27A94091 Transmission Fluid Leakage From Transmission Oil Pan

Transmissions 722.3, 722.5

Part Name	Part Number
Spring kit, K1 accumulator (48)	126 270 44 77

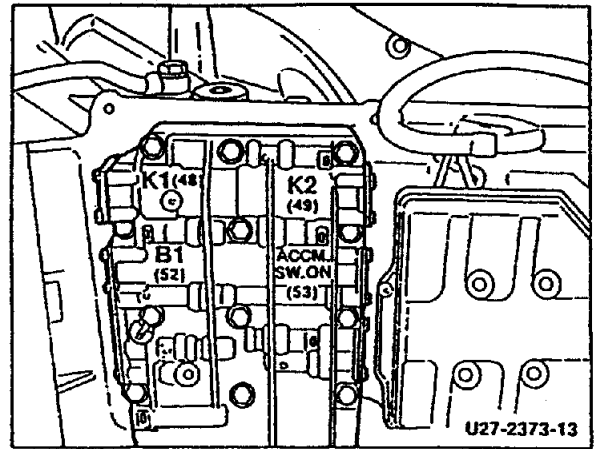
Install modified spring kit in K1 accumulator (48) of valve body.
